ADDENDUM 2

CSP 22-68

Memorial Middle School Heating & Air Condition (HVAC) Improvements Funded through the Elementary & Secondary Emergency Relief (ESSER) Funds

April 8, 2022

EP2.11C

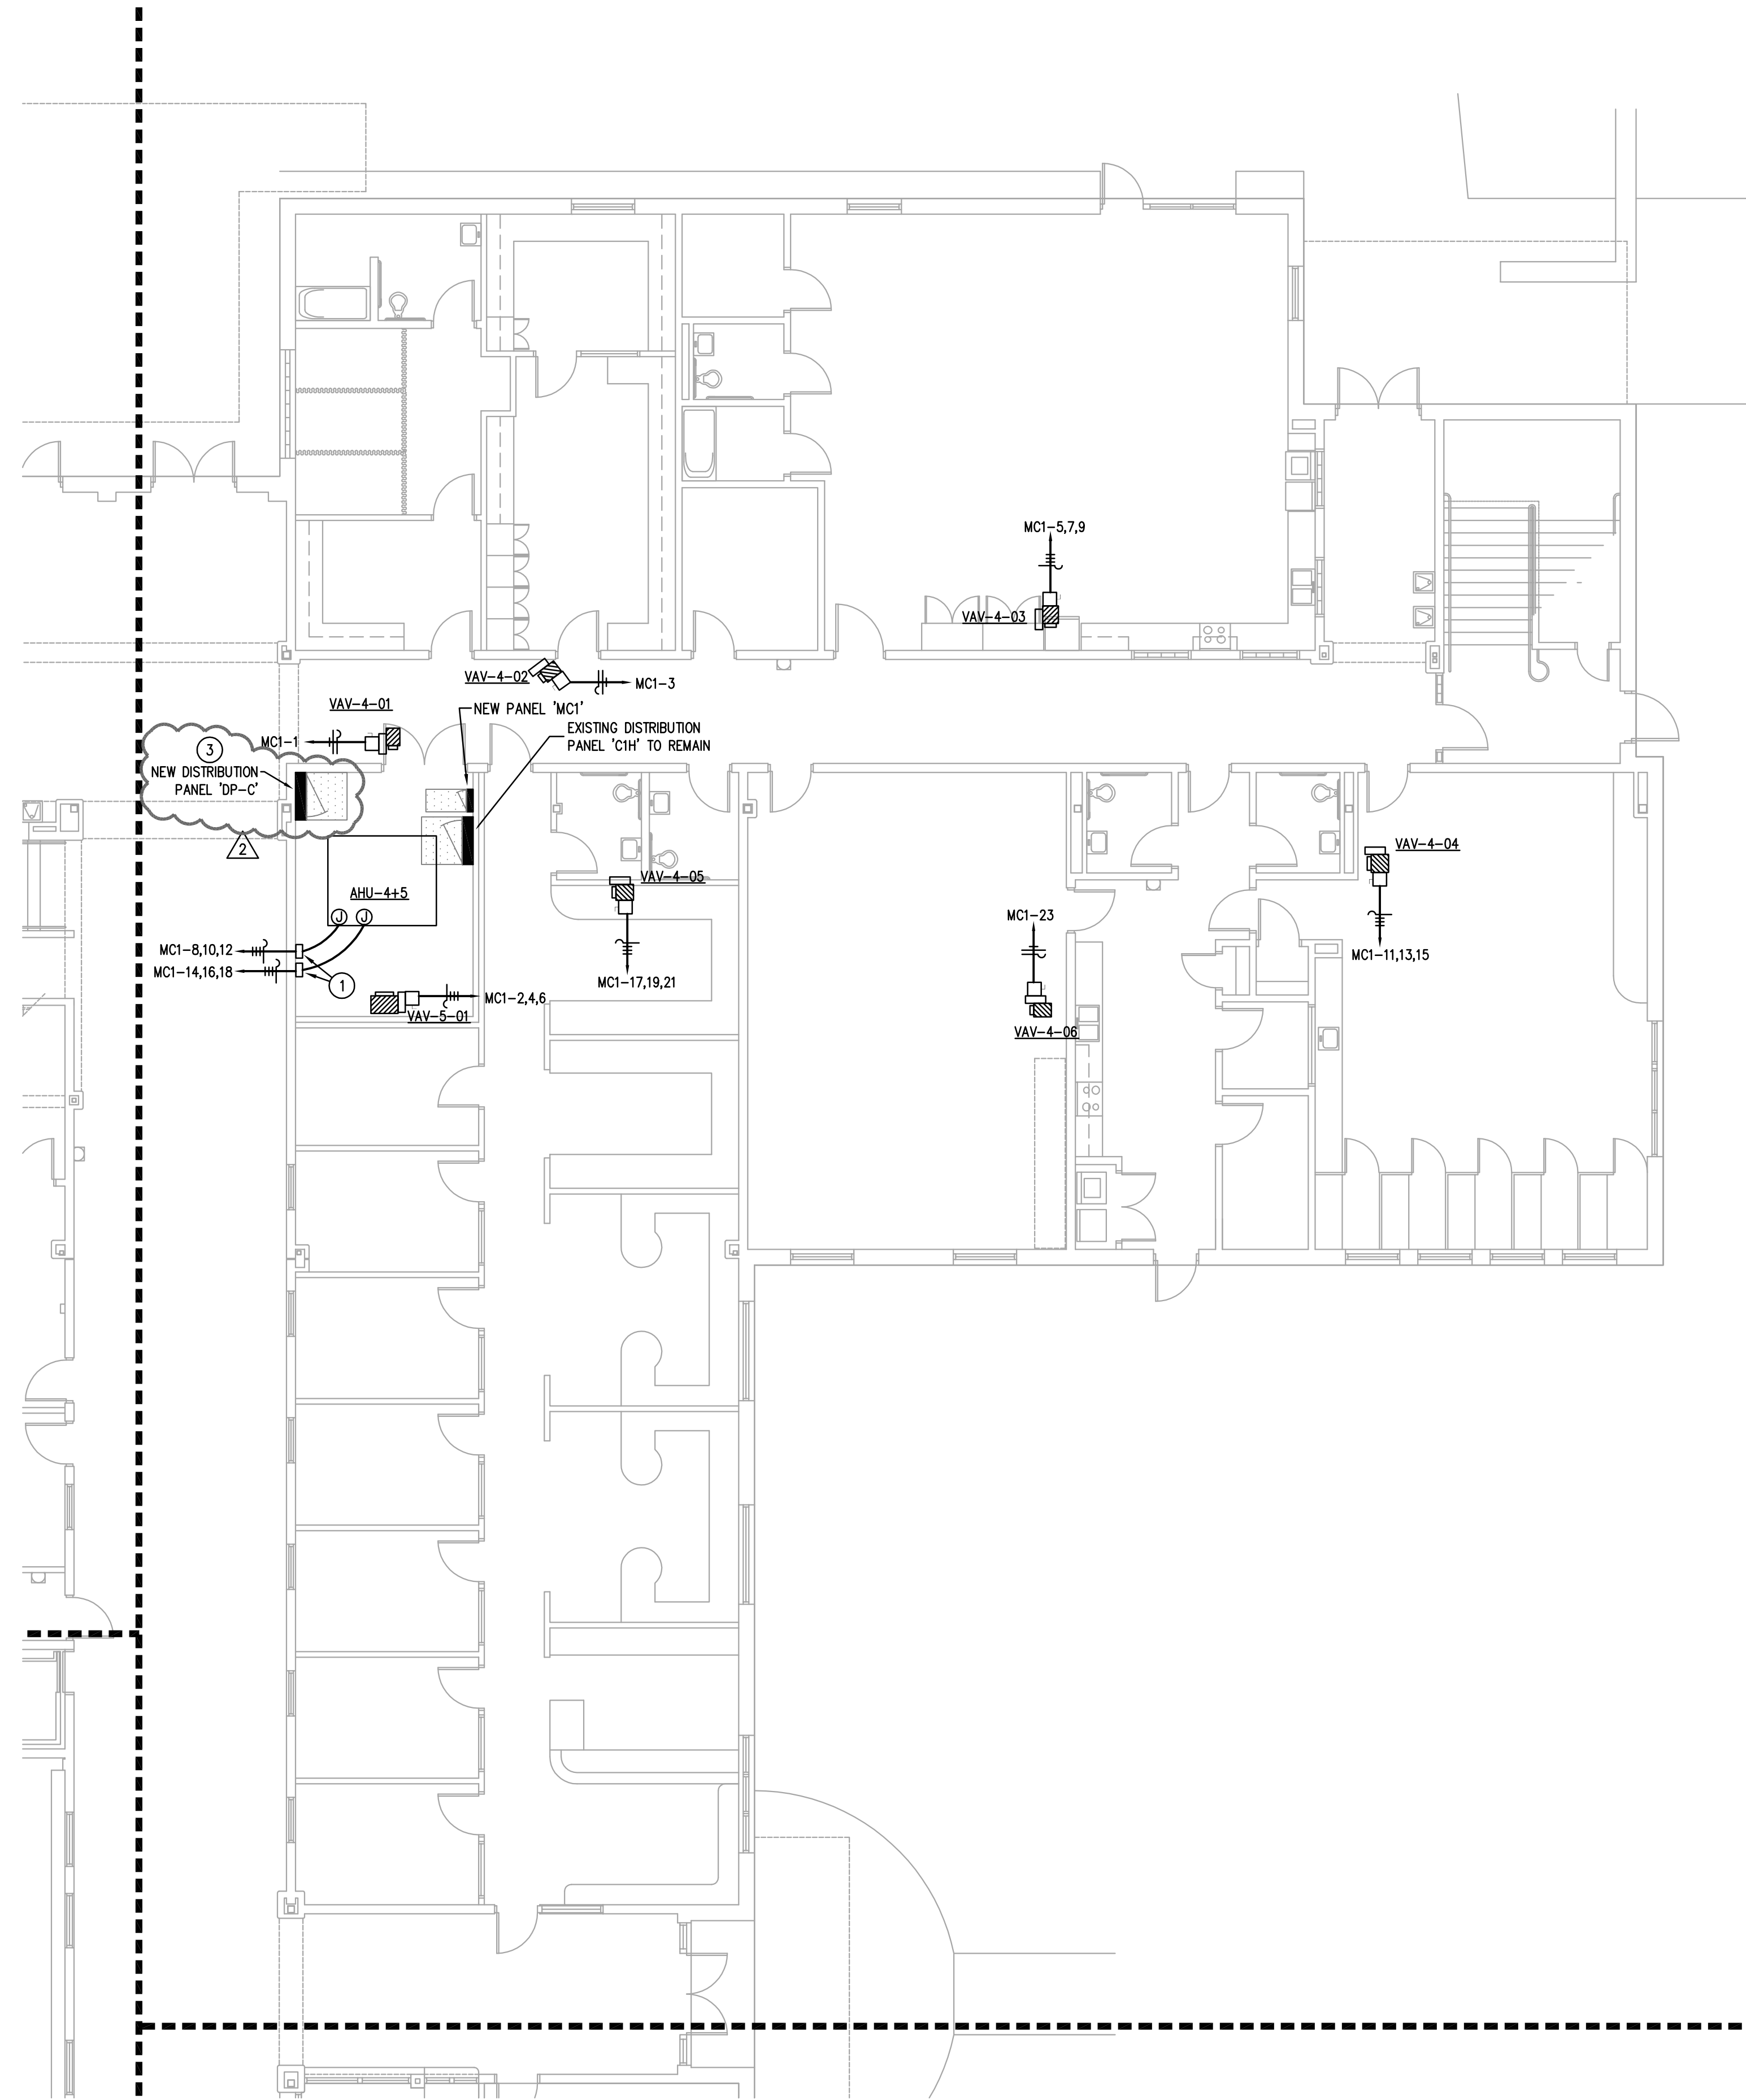
Item 20 SHEET EP2.11C – LEVEL 1 ELECTRICAL POWER PLAN - C

A. Added distribution panel DP-C.

2 CENTRAL PLANT ENLARGED POWER PLAN
 E3.01 1/4" = 1'-0"

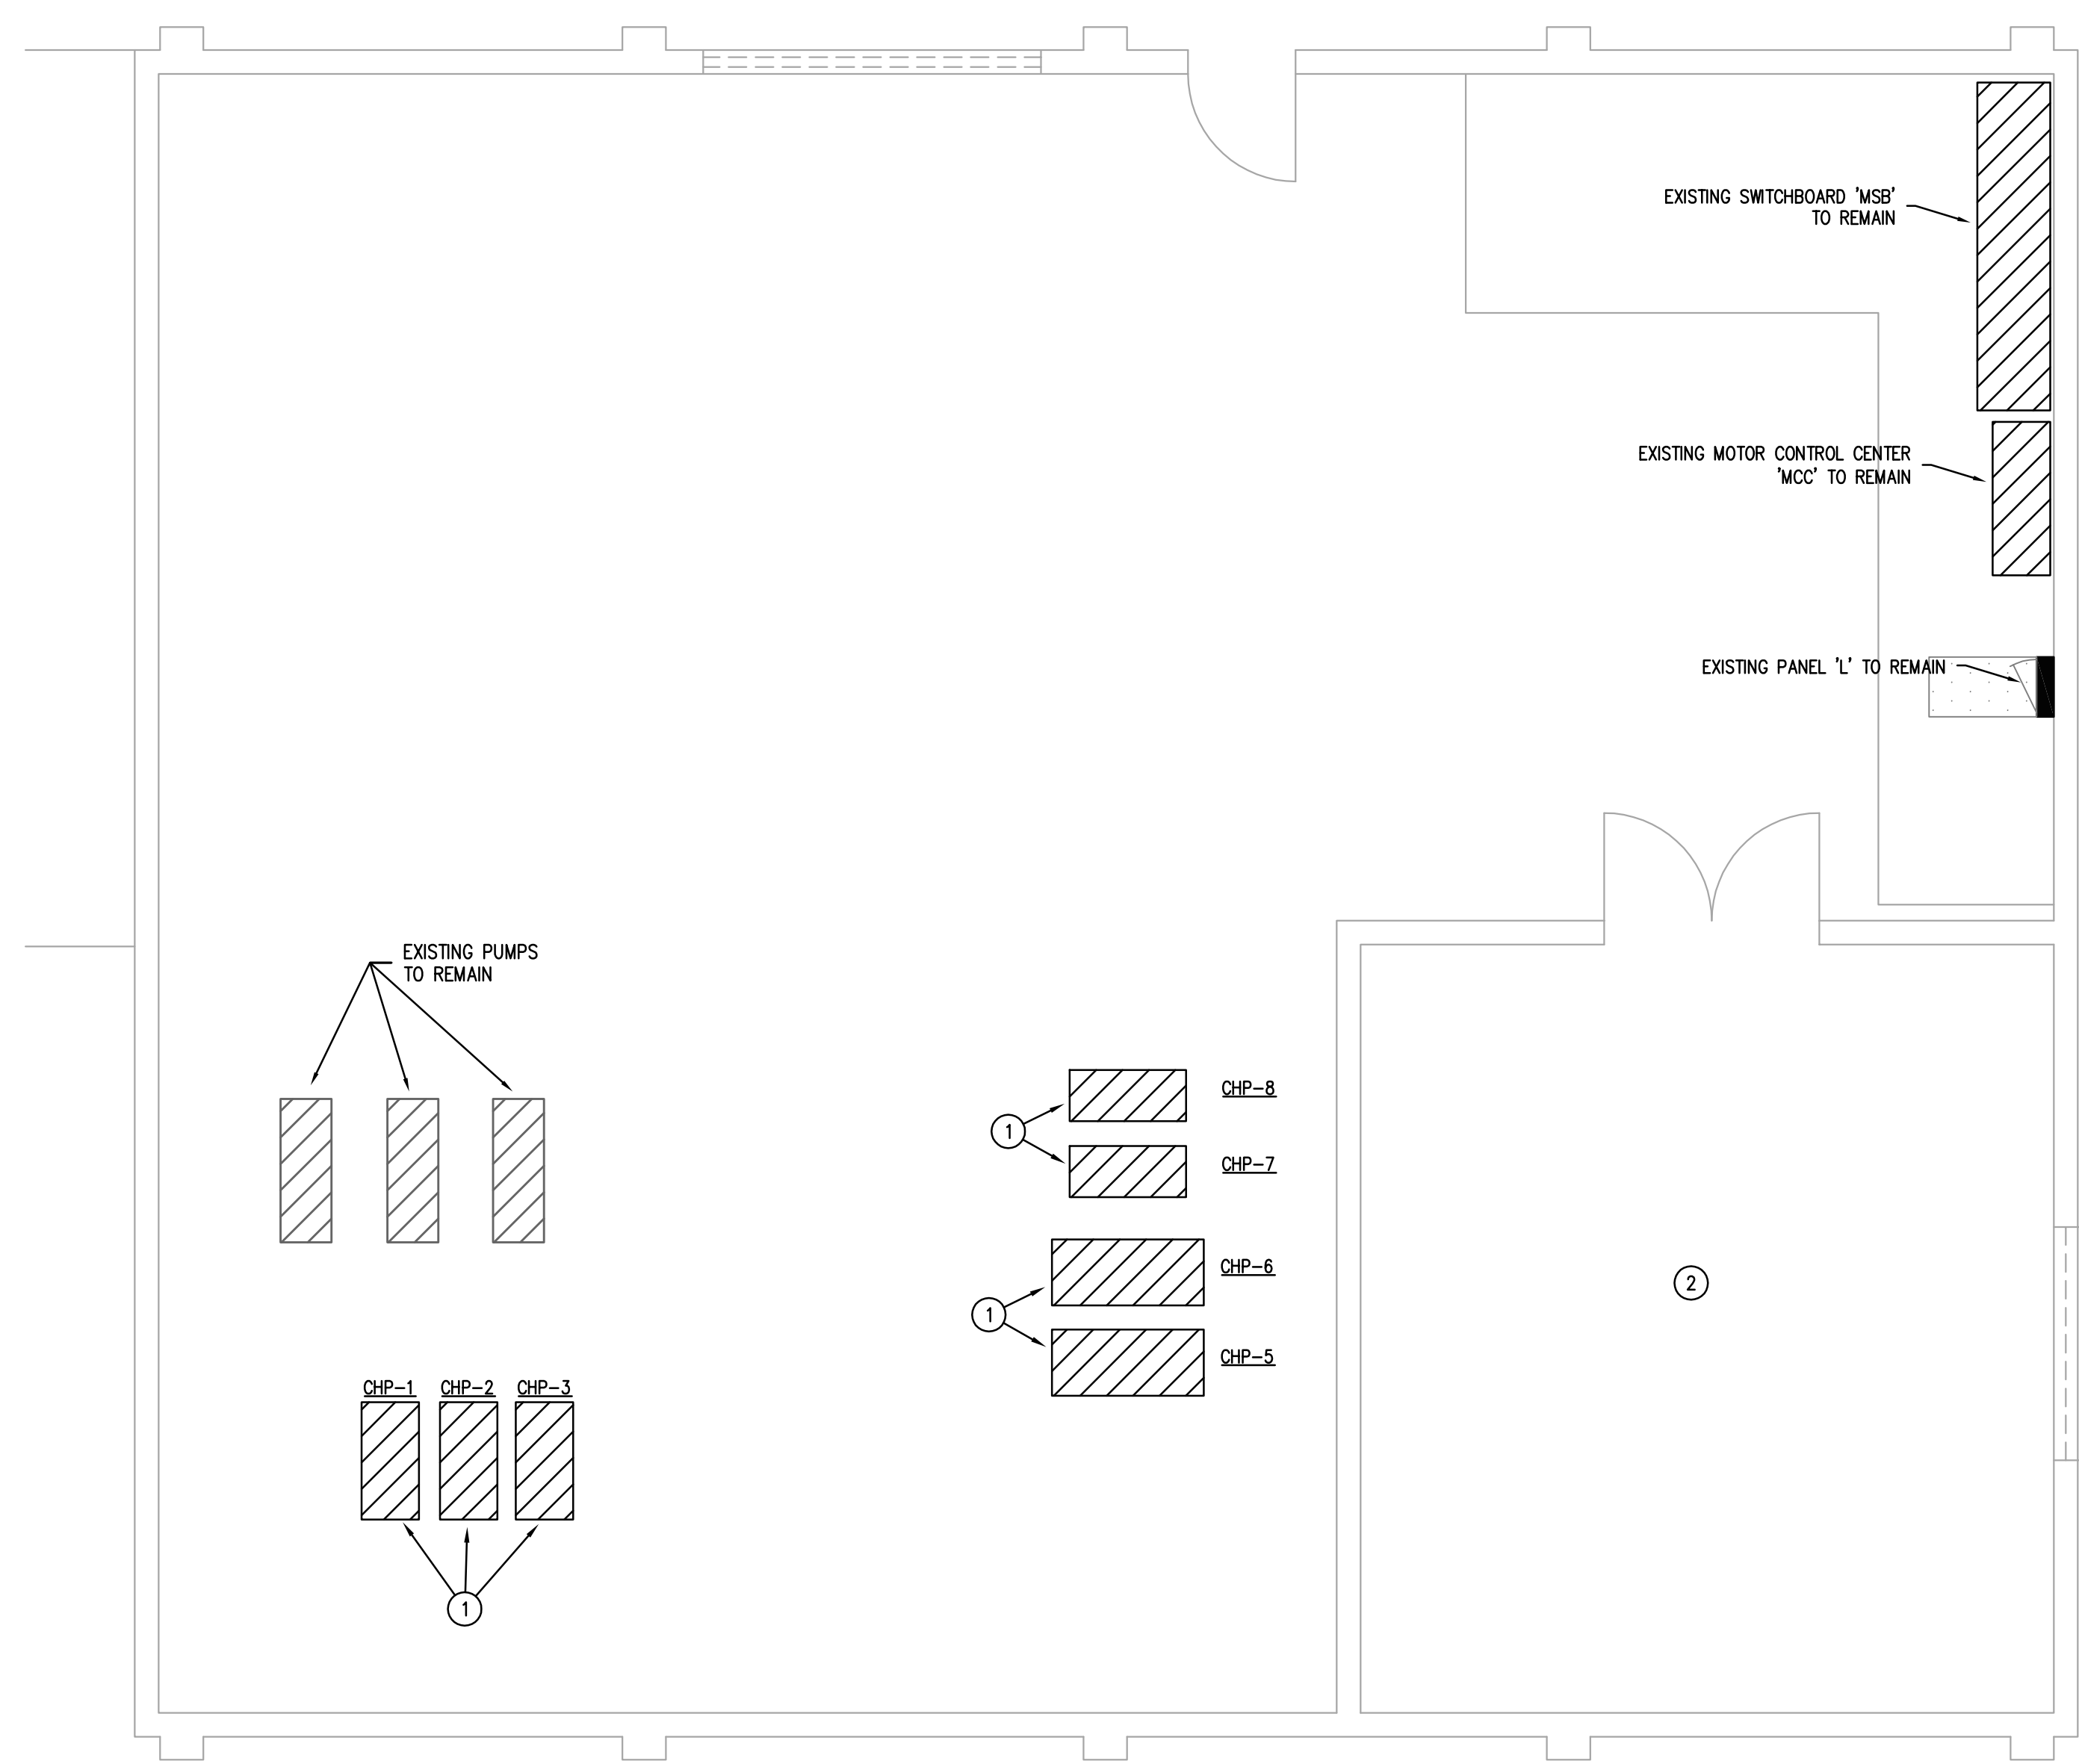
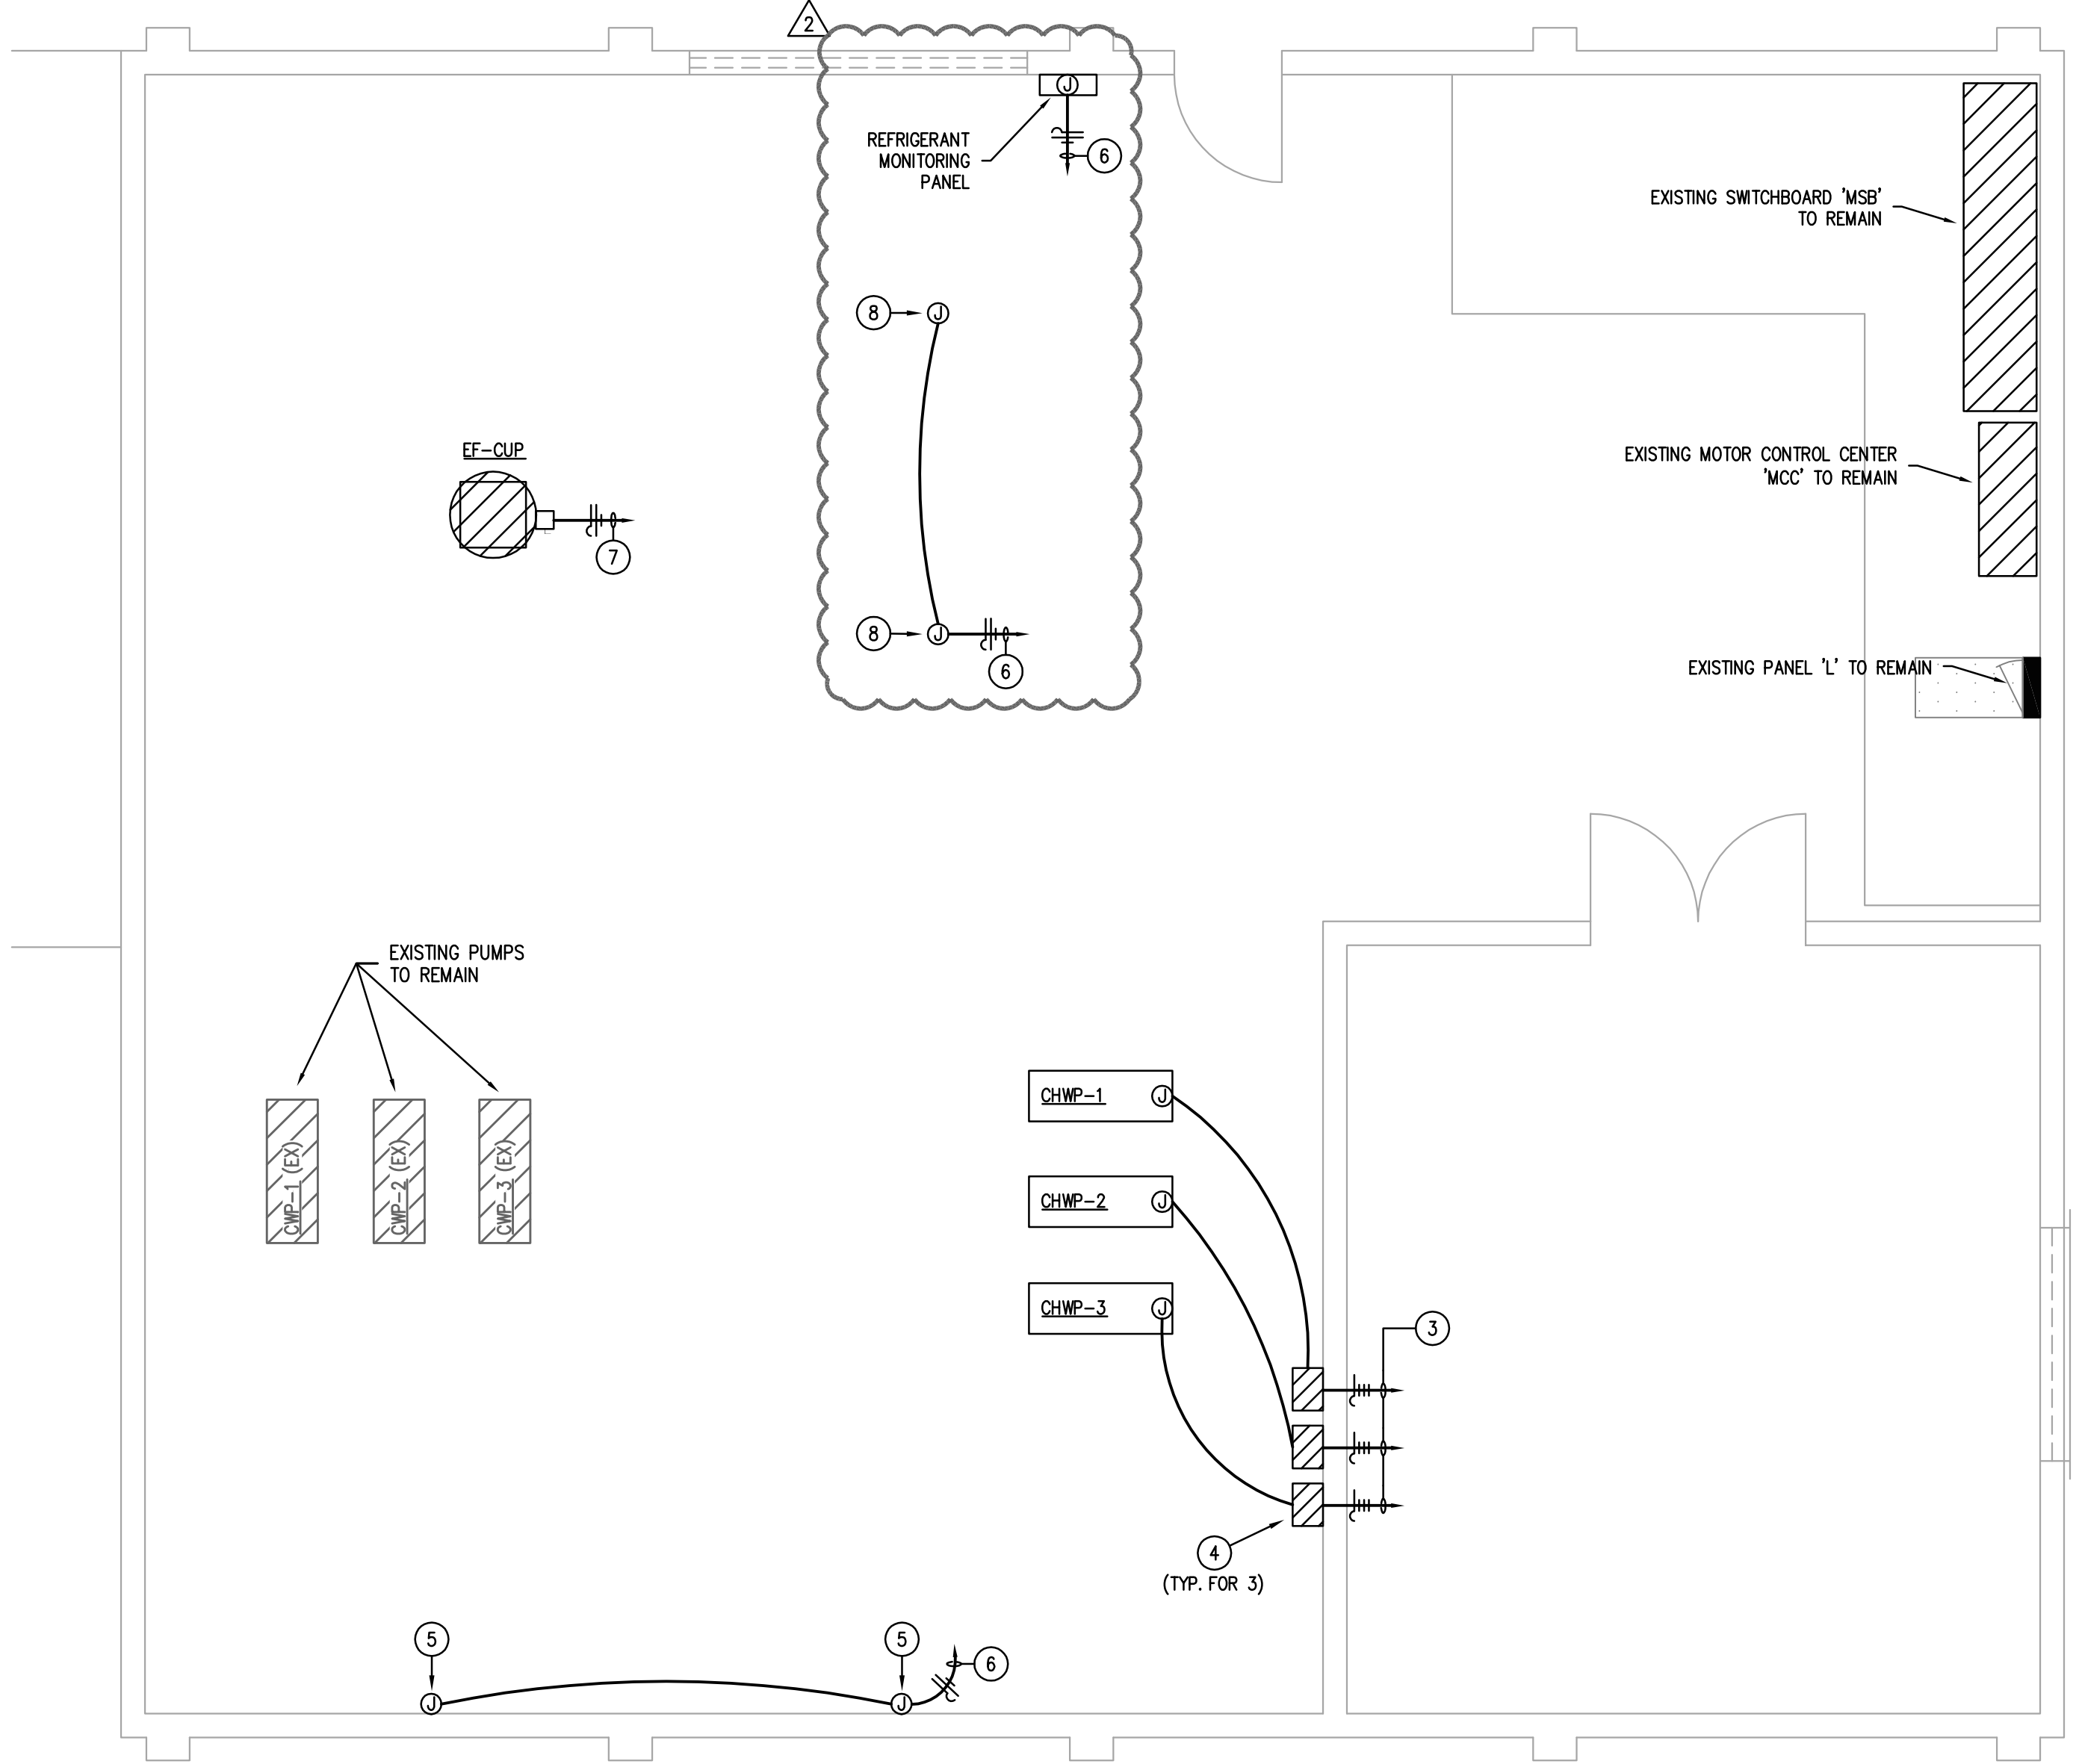
Item 22 SHEET E3.01 – ELECTRICAL ENLARGED POWER PLANS

A. Added power for Refrigerant Monitoring Panel and chiller valves.
